Product Change Notification

112048 - 00

Change Notification #:	112048 - 00
Change Title:	**Intel® Gigabit ET Dual Port Server Adapter (Portville DT OEM Gen) E1G42ETG1P20 MM#897969 &(Portville DT Retail) E1G42ET MM#897658 & E1G42ETBLK MM#897654; Intel® Gigabit ET Quad Port Server Adapter (Portville QT ACS OEM Gen) E1G44ETG2P20 MM#907808 & (Portville QT ACS Retail) E1G44ET2 MM#907804 & E1G44ET2BLK MM#907807** **PCN 112048-00** **Label, Documentation, Product Design** **ROHS Flyer, Remove CDA (E1G42ET, E1G42ETBLK, E1G44ET2, E1G44ET2BLK), Update Labels, and remove old Flash Code**
Date of Publication:	**February 6, 2013**

Existing Label (Example only)	New Label (Example only)

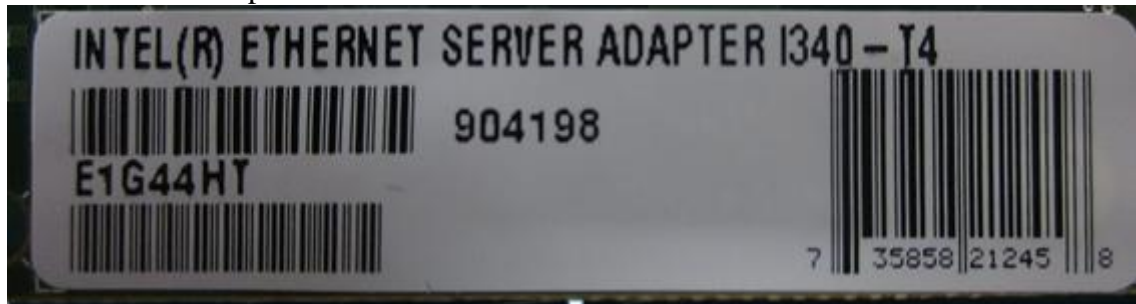
3. Distribution Label Change

Intel Corp is standardizing packaging label formats across the corporation. This will facilitate easier receiving for the end customer.

Intel will begin implementation of UPC and EAN (European Article Number) codes on the product outer case labels.

A new line of text will be added that states either:

- Product is individually labeled for resale.
- Product is not individually labeled for resale.

Additional fields are being added to display the outer case UPC and EAN codes for overall carton quantity. New UPC codes for individual boxes are also being added.

2D matrix label will be added for easier product information scanning.

Customers should be aware that UPC and EAN codes on the outer case carton labels will be changed and that they may need to update their incoming receiving operations. Customers may receive both current and new inventory as the implementation occurs.
